Groundwater Application Review Summary Form

Application # G- 18923

PUBLIC INTEREST REVIEW FOR GROUNDWATER APPLICATIONS

A. GENERAL INFORMATION: Applicant's Name: Stauffer Farms, Inc. County: MARION

Hydrograph

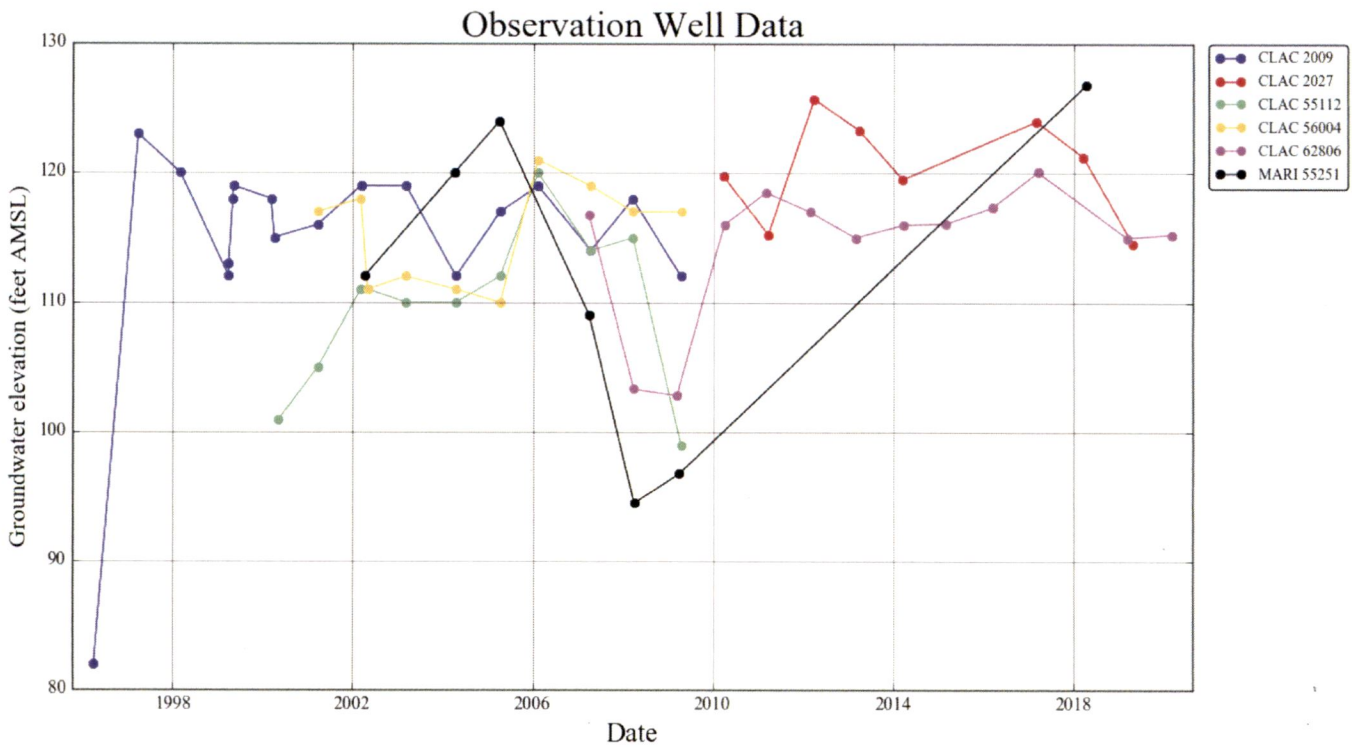
At least 6 observation wells with useful data are within ~2 miles of the proposed POA, though none closer than 1 mile. Data from these wells indicate relative stability within the alluvial aquifer system over the past ~3 decades (see attached Hydrograph). While the proposed rate (1.56 cfs or ~700 gpm) is well above the median reported yield (~45 gpm) for water wells in the surrounding sections, it is within the range of reported yields (see attached Well Statistics). Therefore, it appears that the requested rate may be achievable within the capacity of the groundwater resource. However, the conditions specified in B1(d)(i) and B2(c), above, are strongly recommended for any permit issued pursuant to this application.

Well Interference Analysis (Theis, 1935)

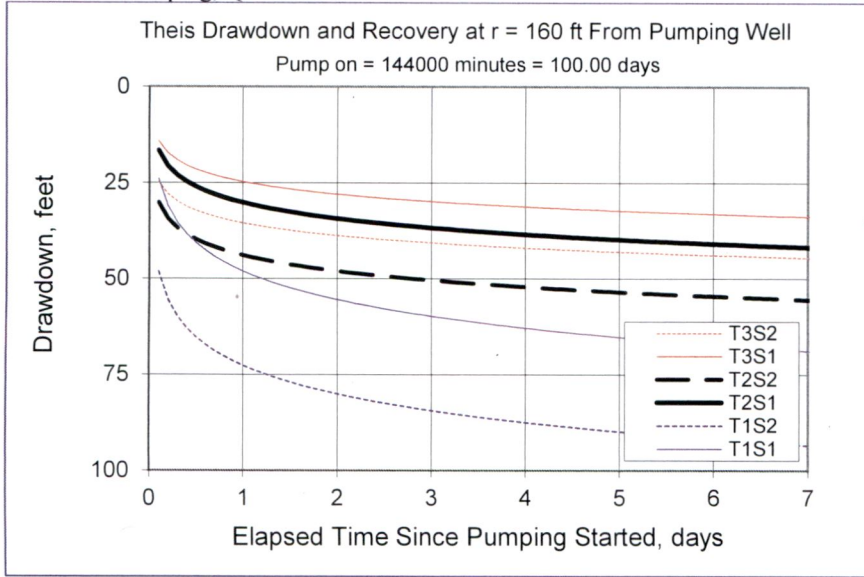
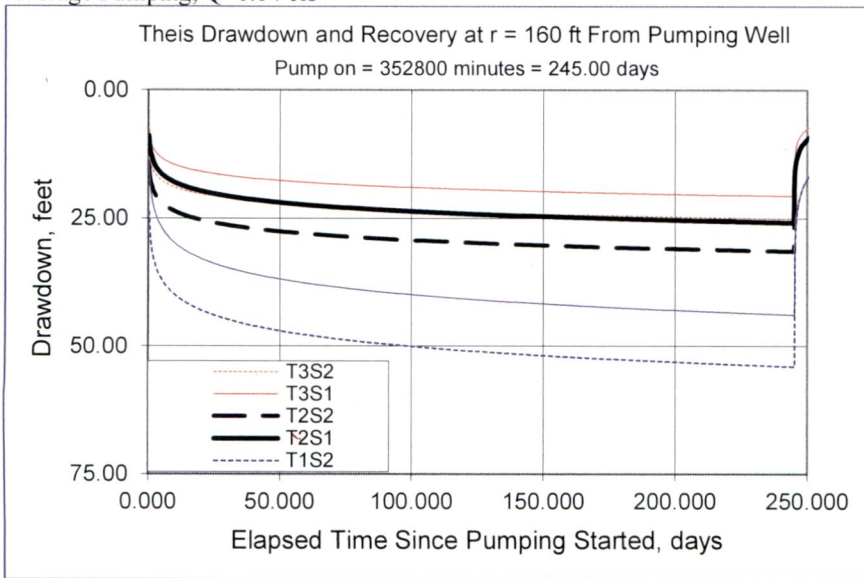
The proposed POA is ~160 ft from the nearest neighboring well, **MARI 1016**, an irrigation well claimed under **GR-751** for up to 0.557 cfs (~250 gpm). **GR-751** is registered to both Stauffer Farms, Inc. and CNR Farms, Inc. **MARI 1016** is reportedly perforated from 100-110 and 200-210 ft bls. Although the exact completion details, including perforated/screened intervals, for the proposed POA have not been provided, it is highly likely that the proposed POA would produce water from a similar zone as **MARI 1016**. To assess the potential interference with **MARI 1016** resulting from the proposed use, a Theis (1935) drawdown analysis was conducted. Hydraulic parameters used for the analysis were derived from regional data and studies (Pumping Test Reports; Conlon et al., 2003, 2005; Iverson, 2002; McFarland and Morgan, 1996; Woodward et al., 1998) or are within a typical range of values for the given parameter within the hydrogeologic regime (Domenico and Mifflin, 1965; Freeze and Cherry, 1979; Halford and Kuniansky, 2002). Results of the analysis indicate that at the maximum proposed rate (1.56 cfs), interference with **MARI 1016** could likely exceed 25 ft within 1 day of continuous pumping (see attached Well Interference Analysis – Maximum Pumping). Under a more modest pumping scenario wherein the proposed POA is pumped

at the minimum rate (~0.64 cfs) necessary to achieve the proposed duty (311.25 af) within the proposed period of use (~245 days), results of the analysis still indicate that interference with MARI 1016 is likely to exceed 25 ft before the end of the irrigation season (see attached Well Interference Analysis – Average Pumping). Condition 7n (recommended for any permit issued pursuant to this application) stipulates that pumping must be curtailed if interference exceeds 25 ft in any neighboring well with senior priority. **Therefore, it is unlikely that the proposed use will be available in the amounts requested.**
